NO SIGNIFICANT HAZARDS DOCUMENTATION

Unit 2 Technical Specification 6.4

The staff requested that additional information be supplied concerning the change to Technical Specification 6.2.1.

FIGURE 6.2-1
OFFSITE ORGANIZATION

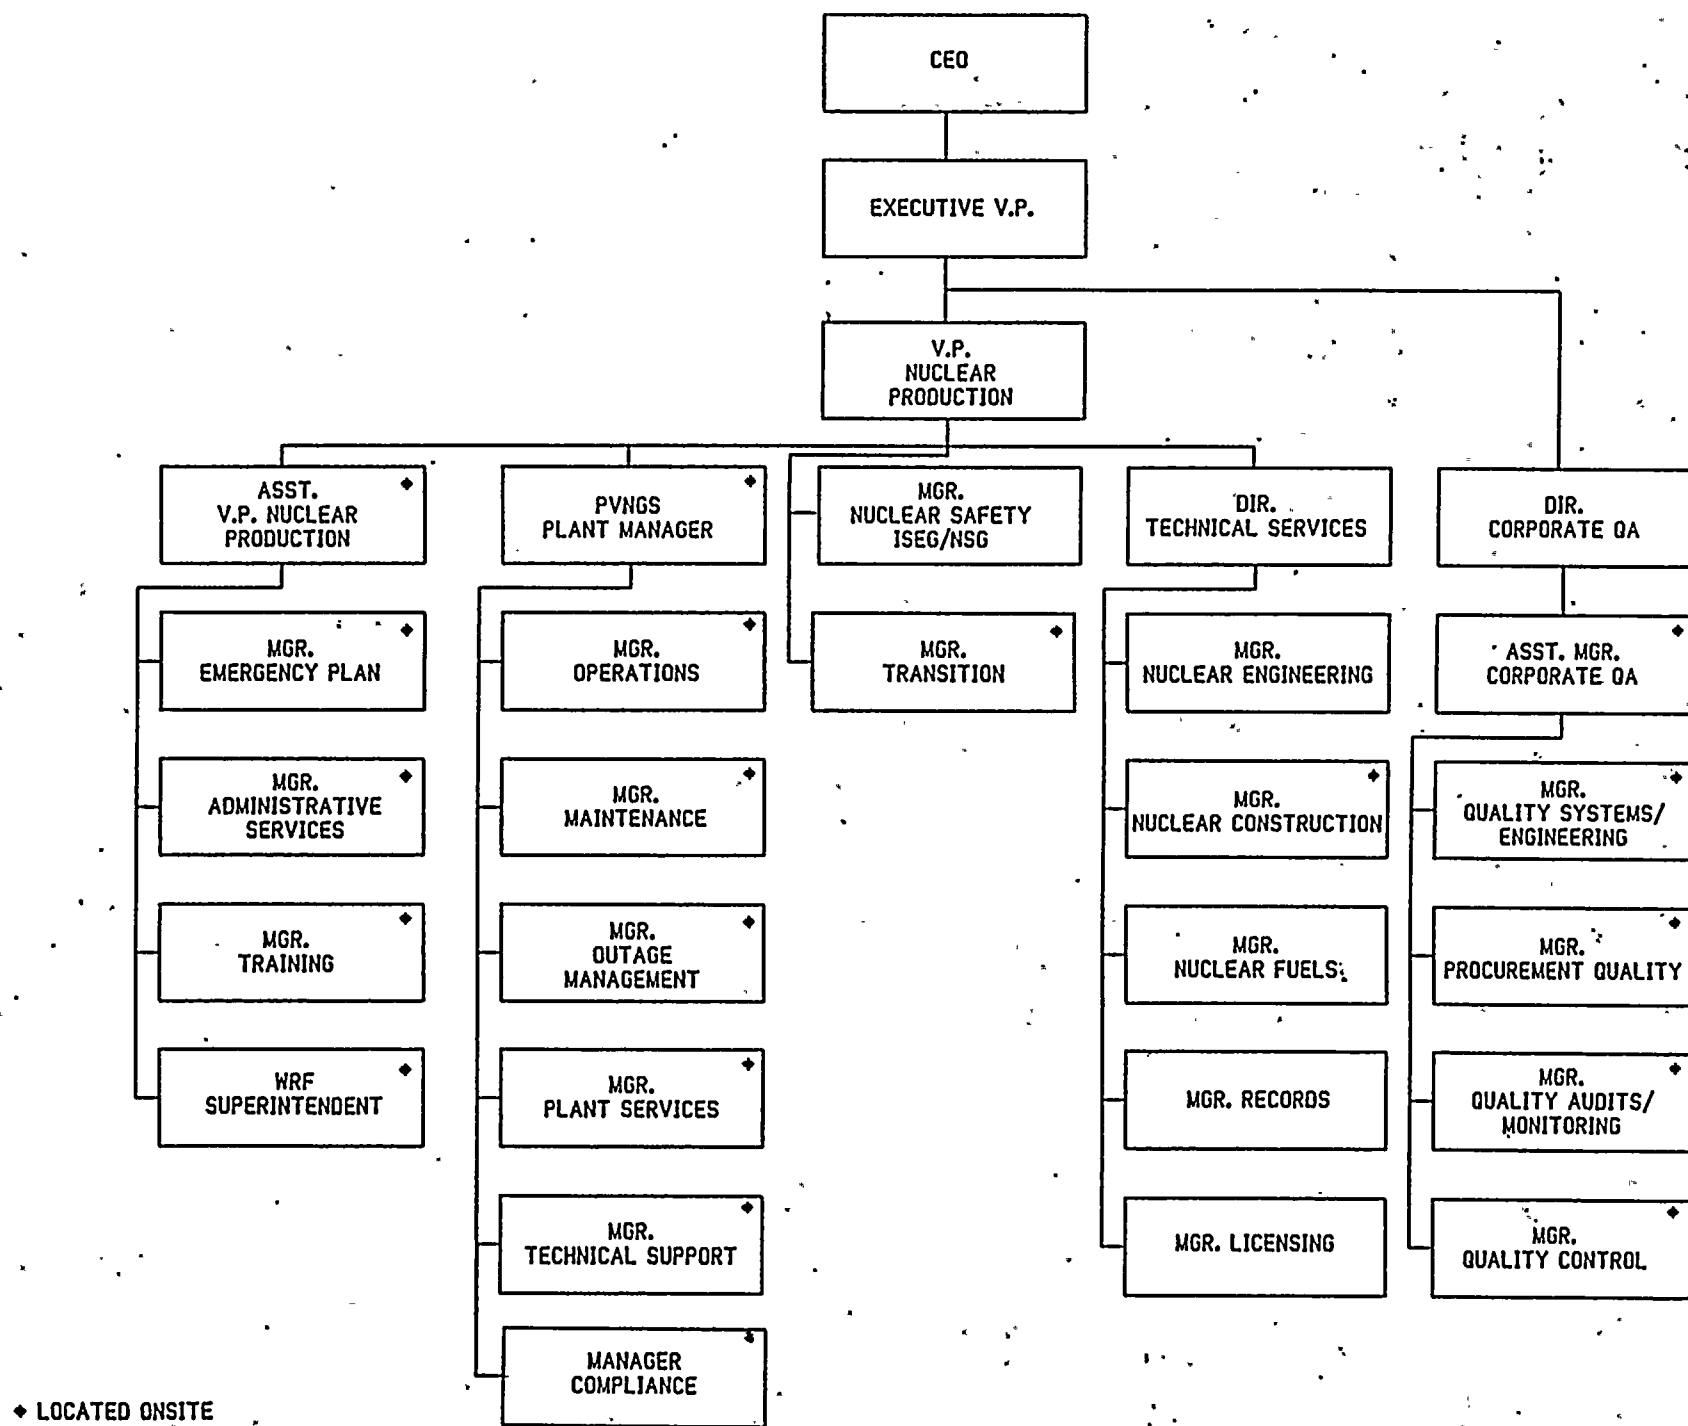
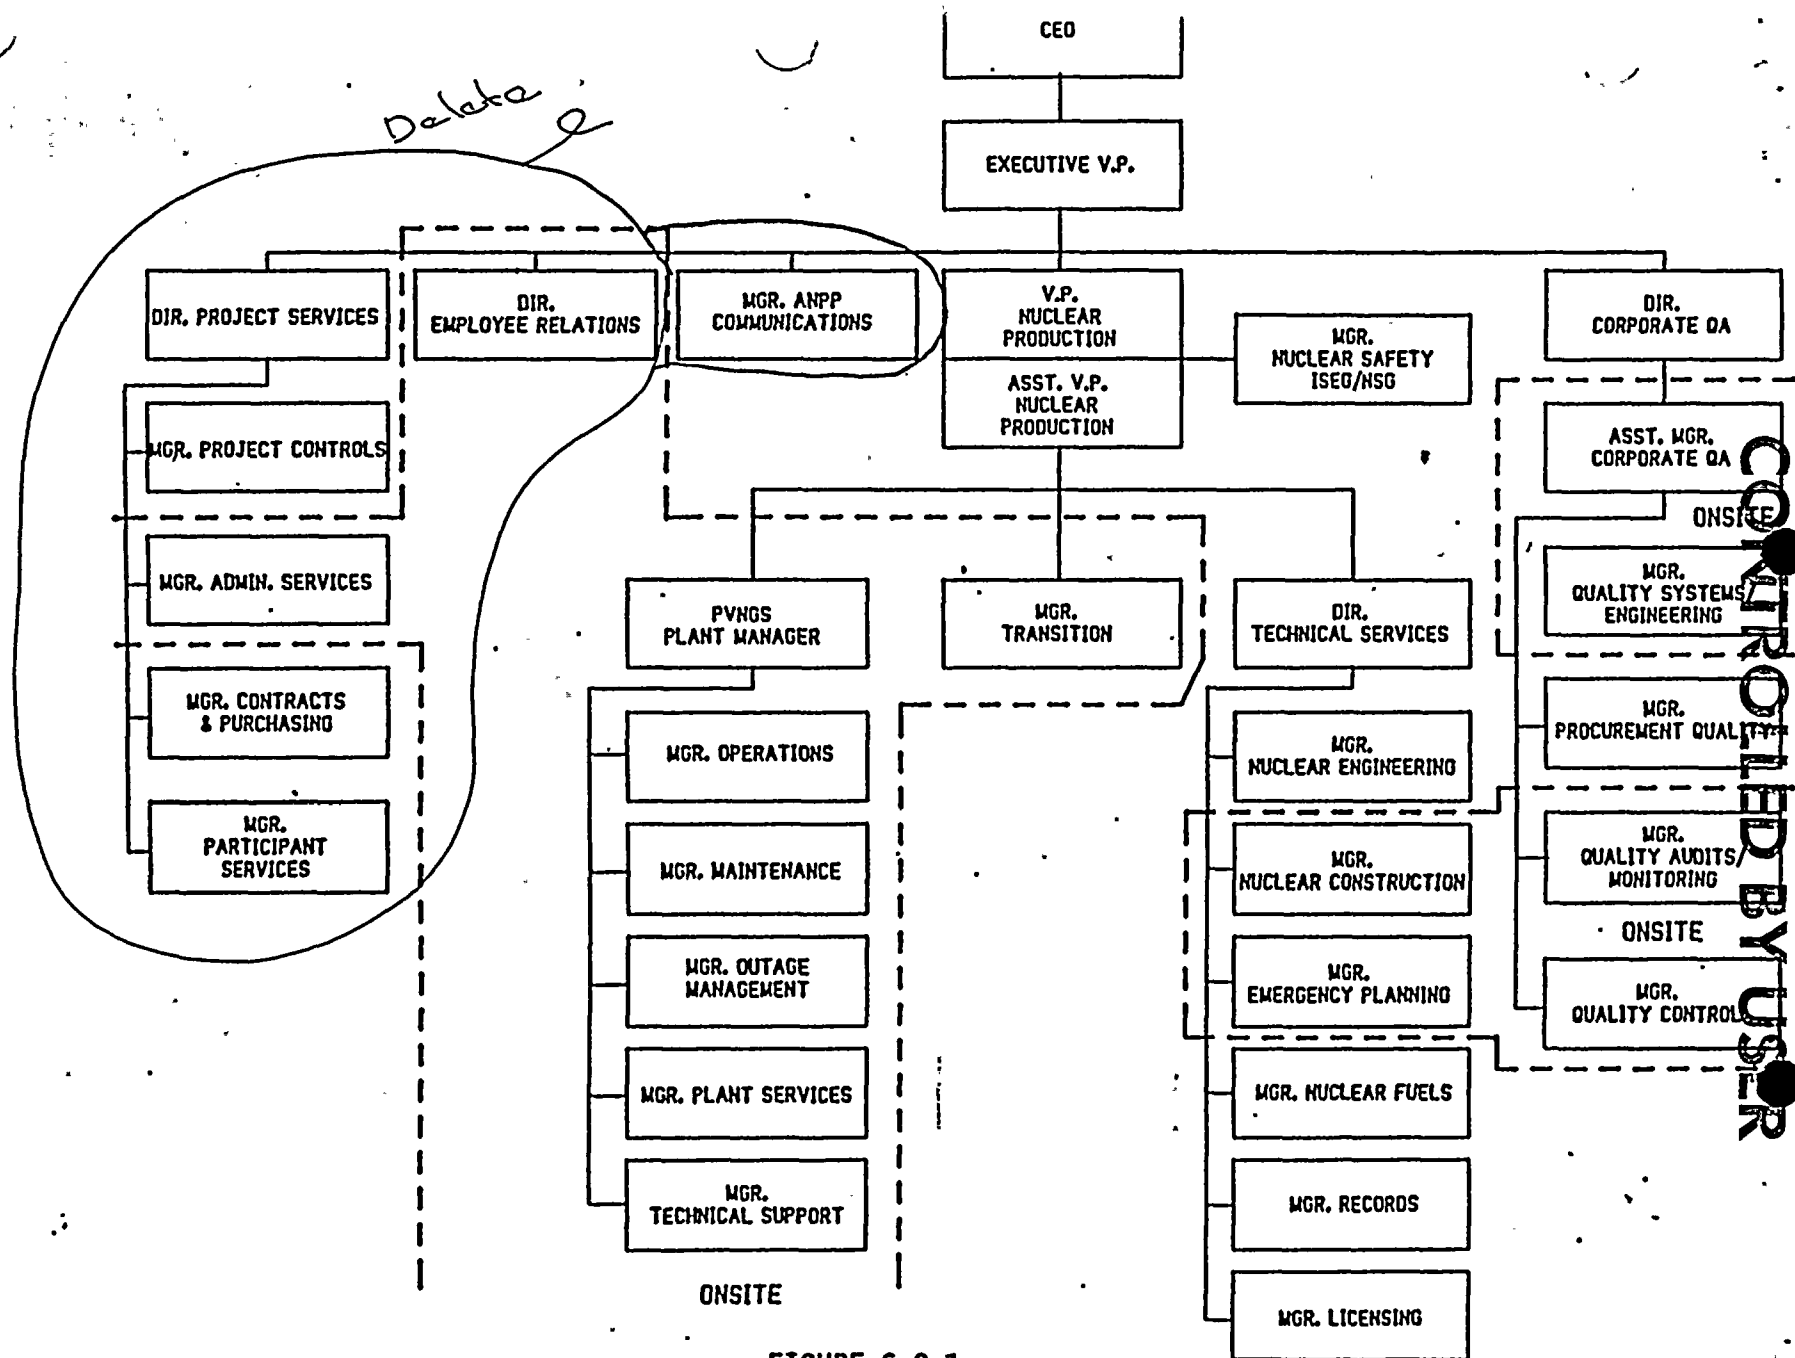
The major change is depicted on Figure 6.2-1. The Assistant Vice President, Nuclear Production, is shown separated from the Vice President, Nuclear Production, and is assigned direct responsibility for four support functions: Emergency Planning, Administrative Services, Training, and Water Reclamation Facility Operations. This change was made to allow those managers who have direct responsibilities for plant operation and safety to concentrate resources on those areas and to provide effective management for necessary support functions.

An additional change can be seen on Figure 6.2-1. The Compliance Department reporting to the PVNGS Plant Manager will now be headed by a manager with one or more supervisors reporting to him. This change is intended to increase the effectiveness of this group in responding to Licensee Event Reports and other interfaces with regulatory matters.
